**NOTICE OF MEETING**  
**PLANNING AND ZONING COMMISSION**  
**6:30 P.M. – December 12, 2019**

PLANNING & ZONING COMMISSION ITEM:  
VR-19-17  
**VARIANCE**  
CIBOLO CLIFF RANCHES

PLANNING AND ZONING COMMISSION ITEM:  
PC-19-20  
**PRELIMINARY PLAT**  
**CIBOLO CLIFF RANCHES**

**SUBJECT:** 4S Ranch, Unit 7B Prelim Plat Review

SUBDIVISION PLAT ESTABLISHING  
**CIBOLO CLIFF RANCHES SUBDIVISION**

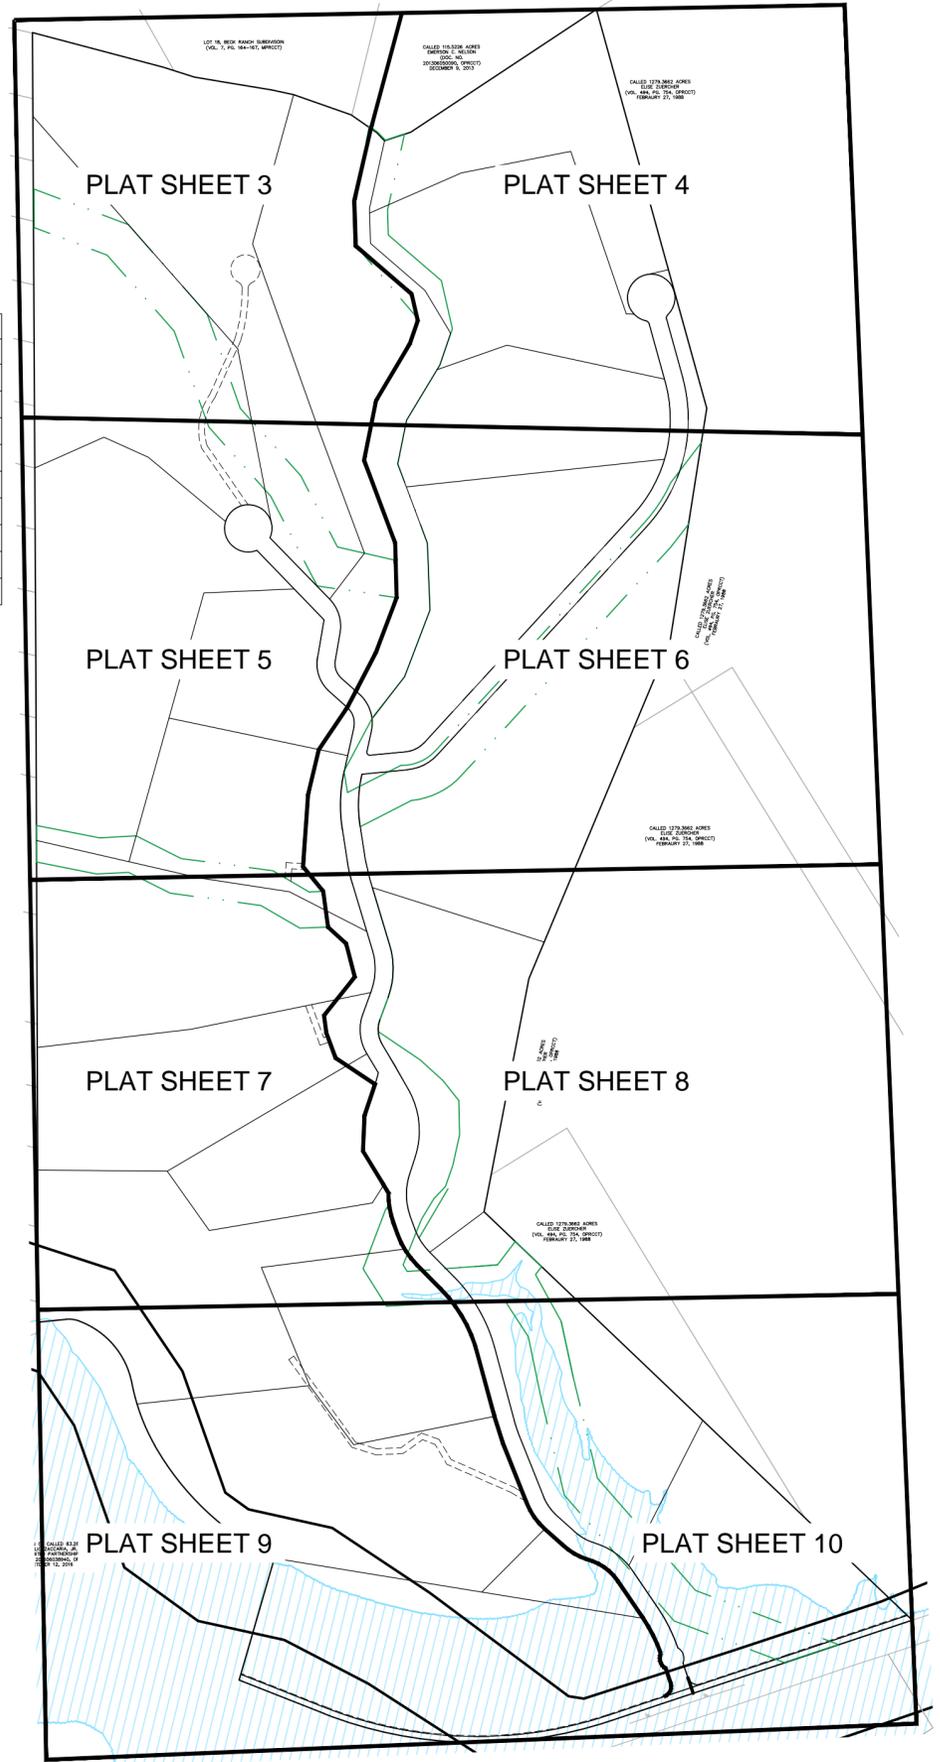
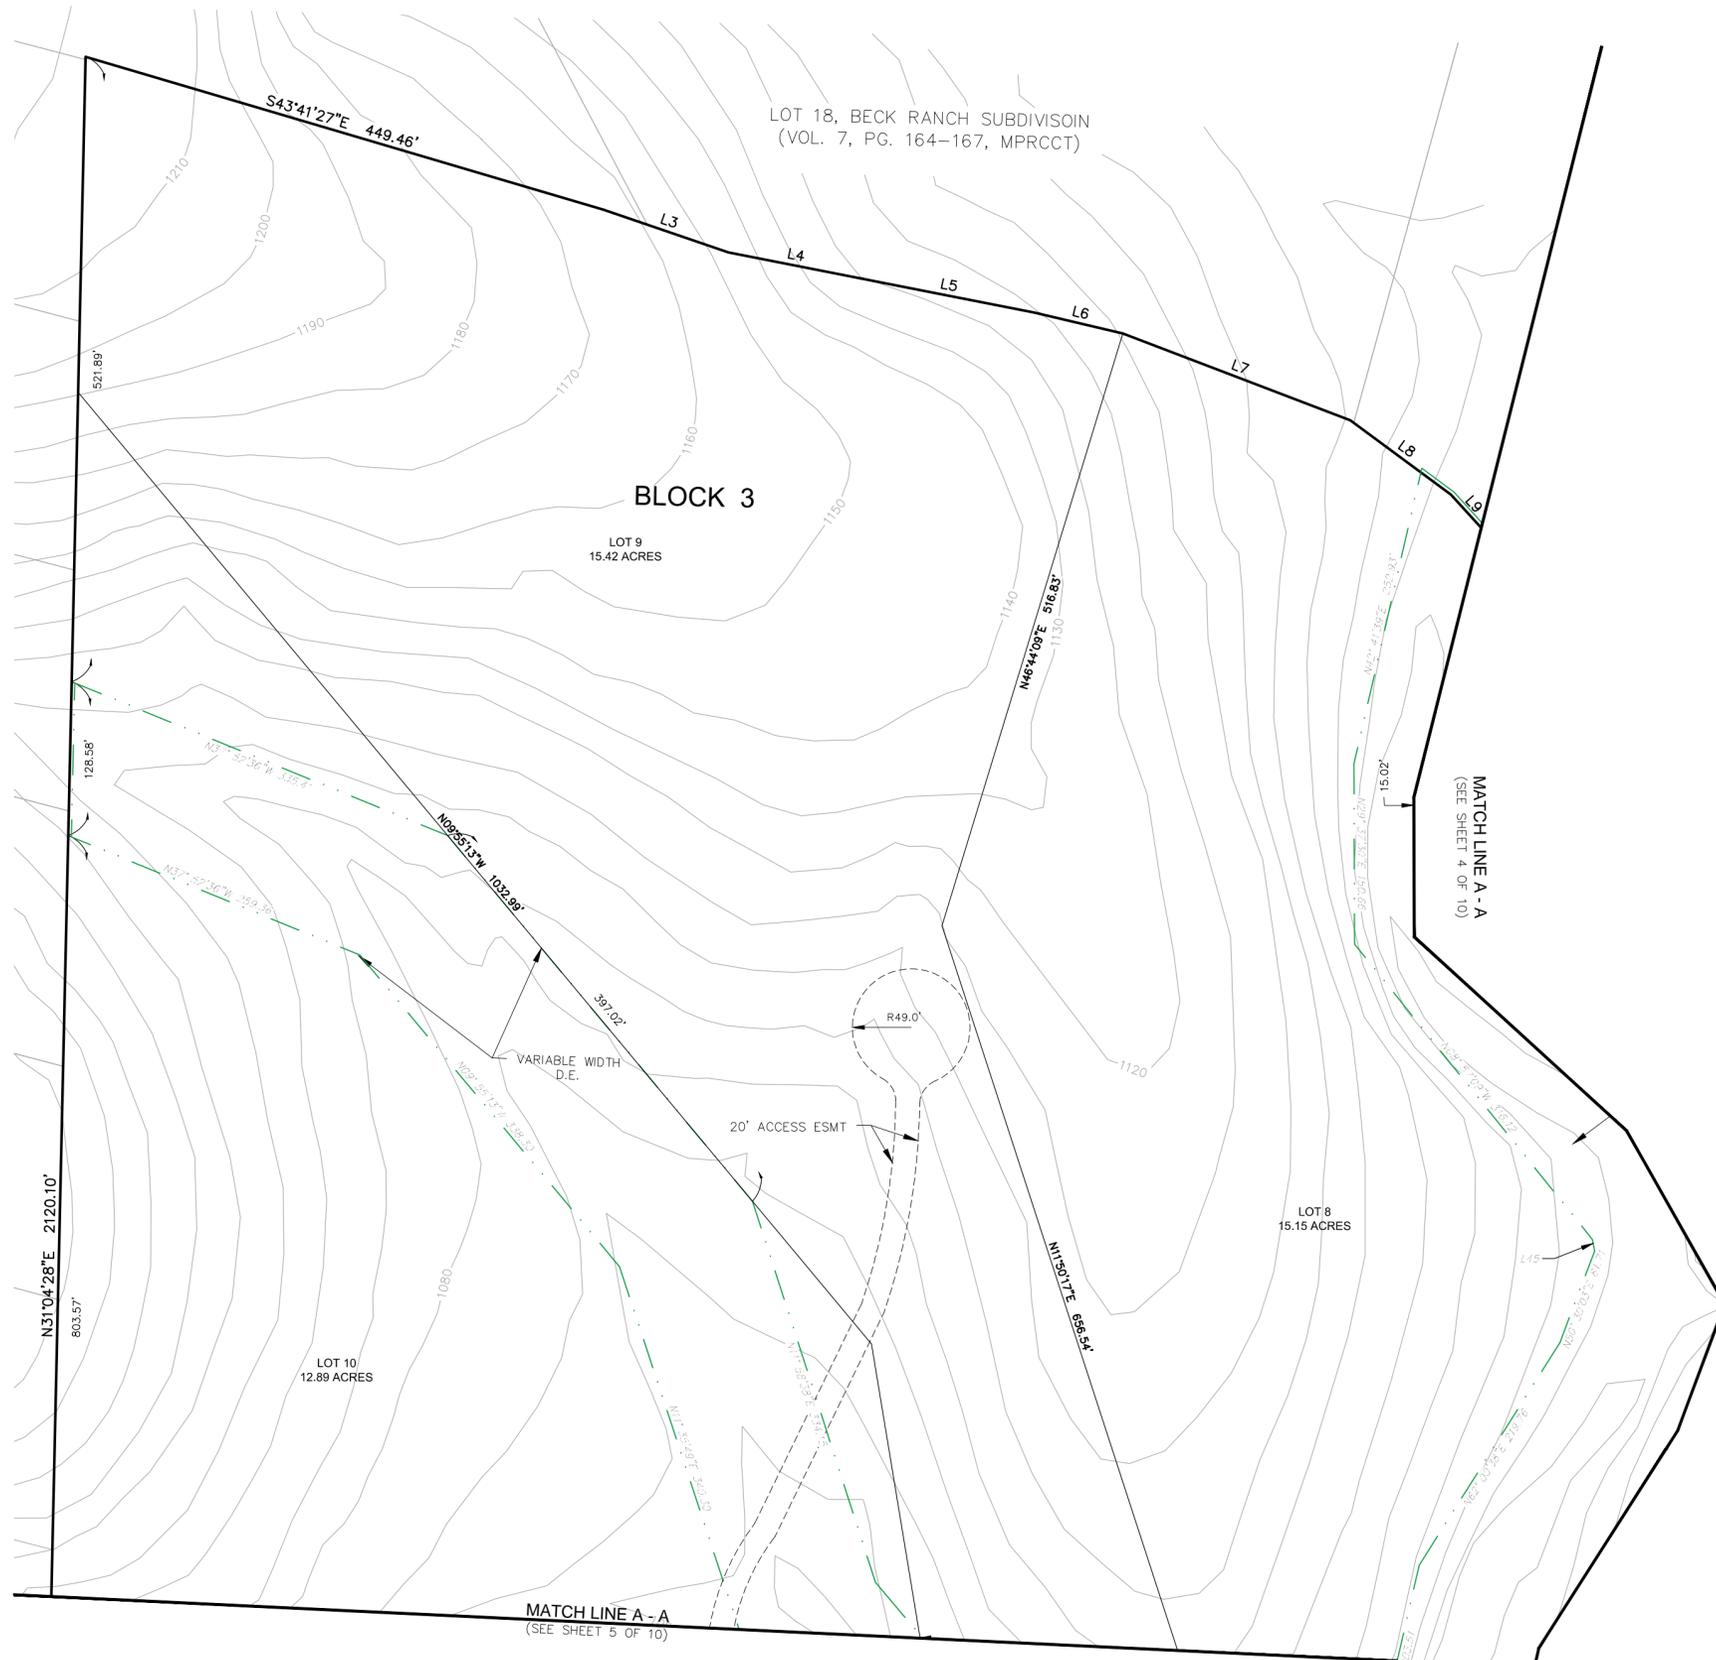
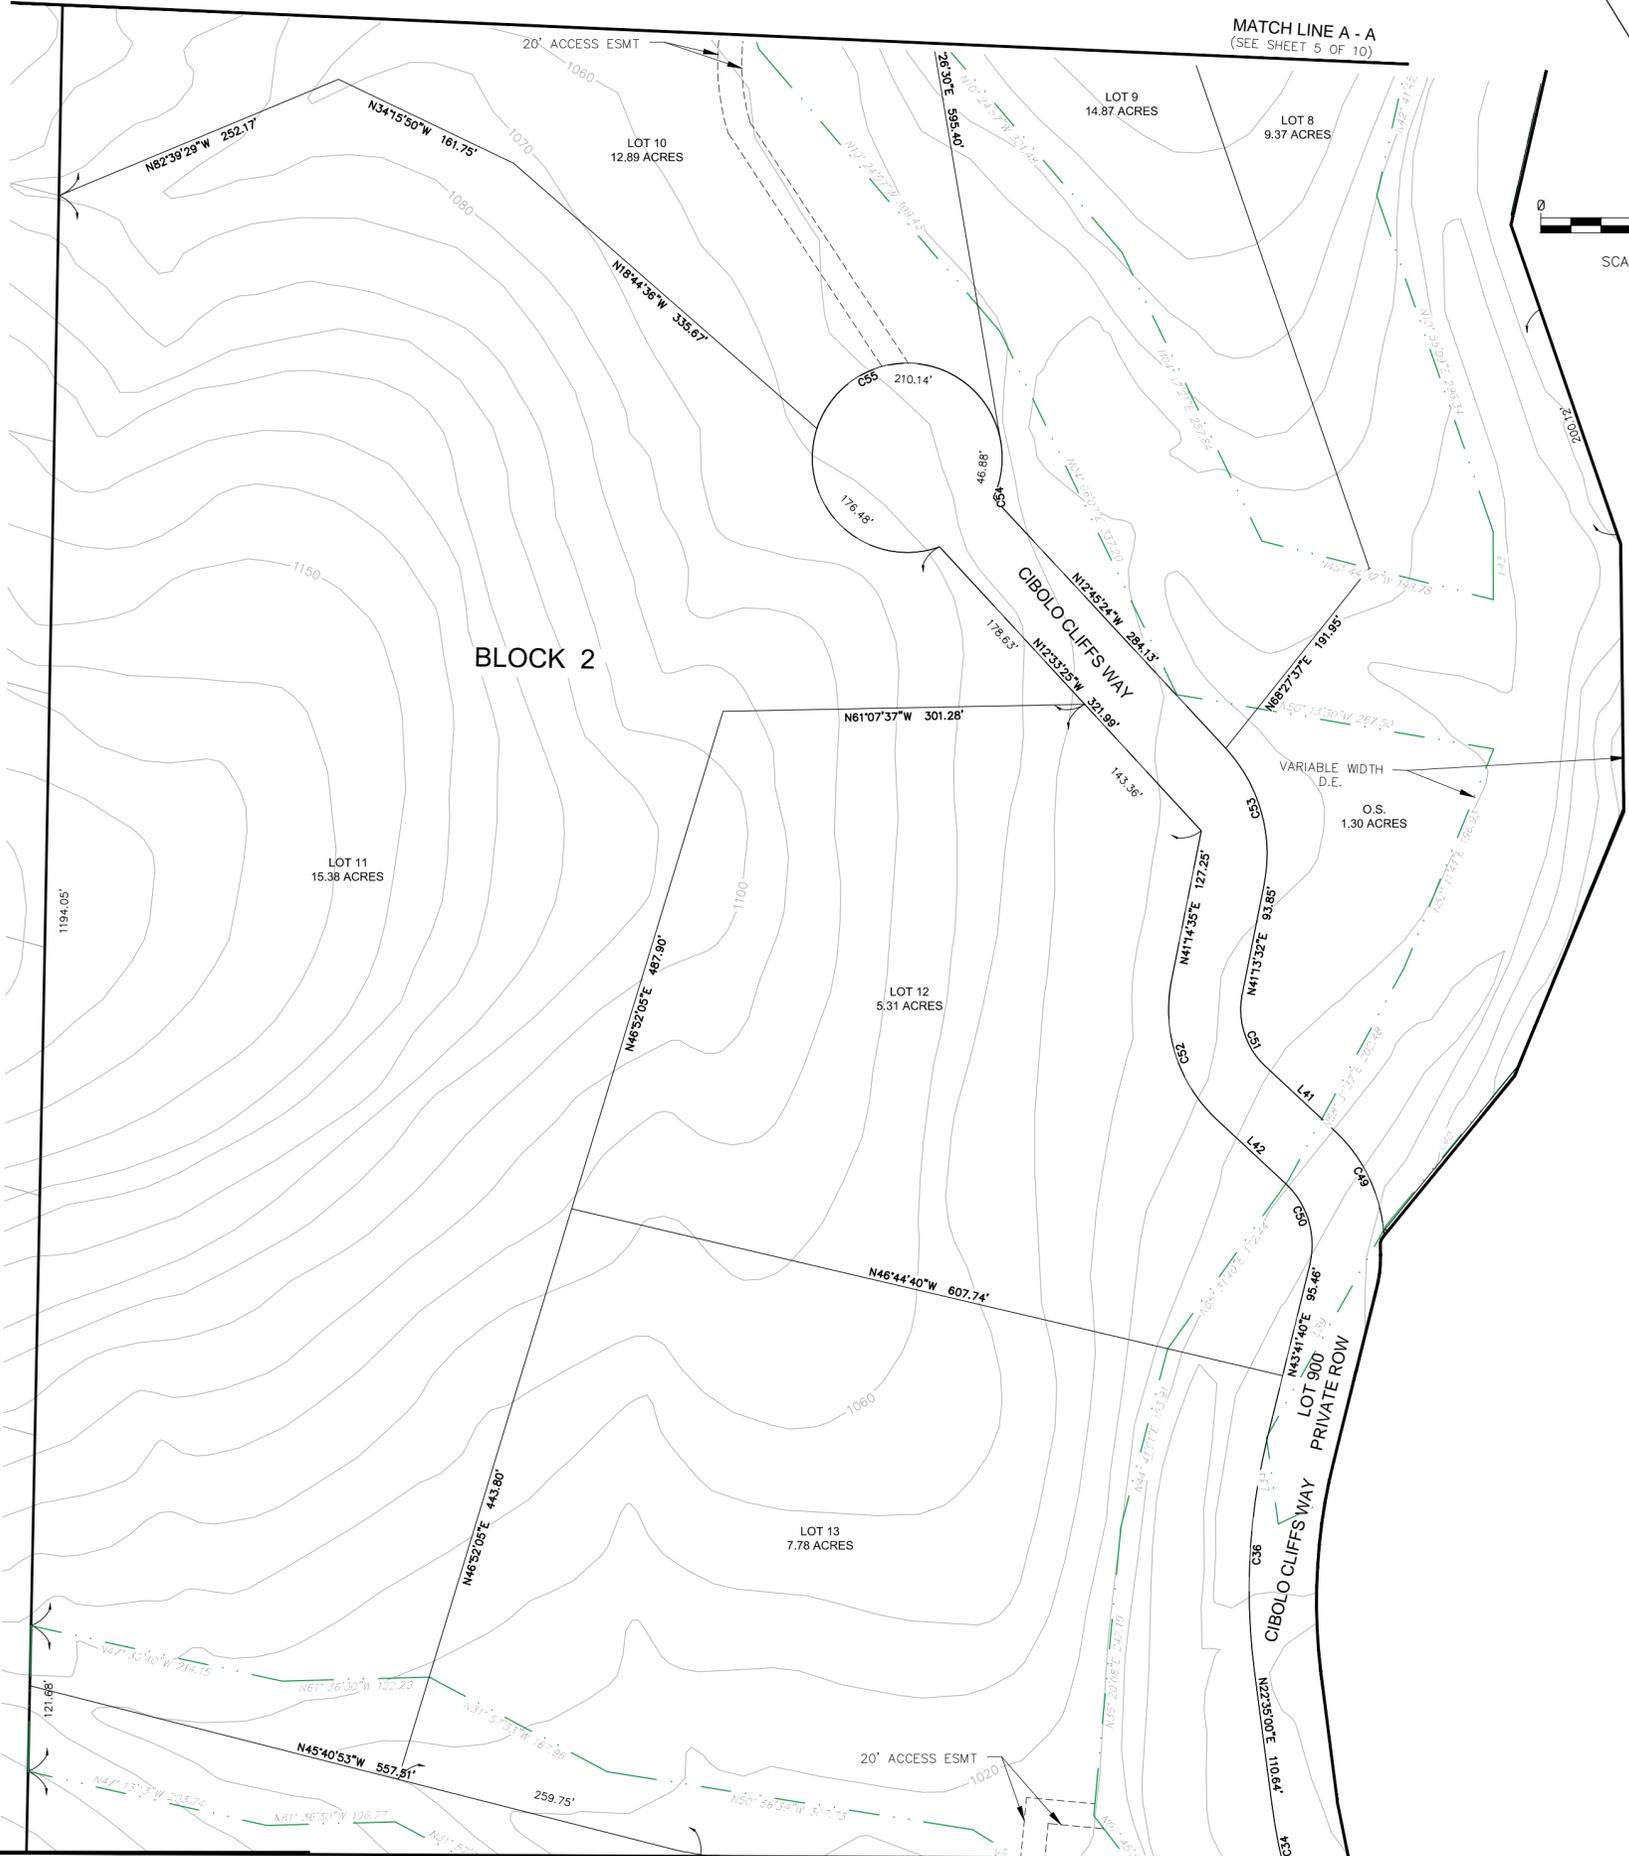
1. Plat scale must not exceed 1" = 100 feet.
2. Missing length of streets
3. Note 13 - revise to say "two feet" instead of one. "...must have a flood slab elevation...a minimum of ~~one foot~~ two feet above the 100-year water flow elevation..."

4. Note 4 & 12 – Lot 900 is open space/drainage easement but includes proposed roadway. Revise to show road ROW separate from drainage easement.
5. Include block numbers for each lot (it's been noted a variance has been requested for block lengths).

8. A minimum of two corners of the subdivision referenced to State Plane Grid Coordinates.
9. Show city limits and limits of the City's ETJ on location map and plat (i.e. FM 1863)

13. Label drawing as "Subdivision Plat", not "Preliminary Plat".
14. Provide acreage of all drainage easements within each lot. Keep in mind, fences will not be allowed within the drainage easements. All easements must be labeled with bearing and direction to a fixed location.
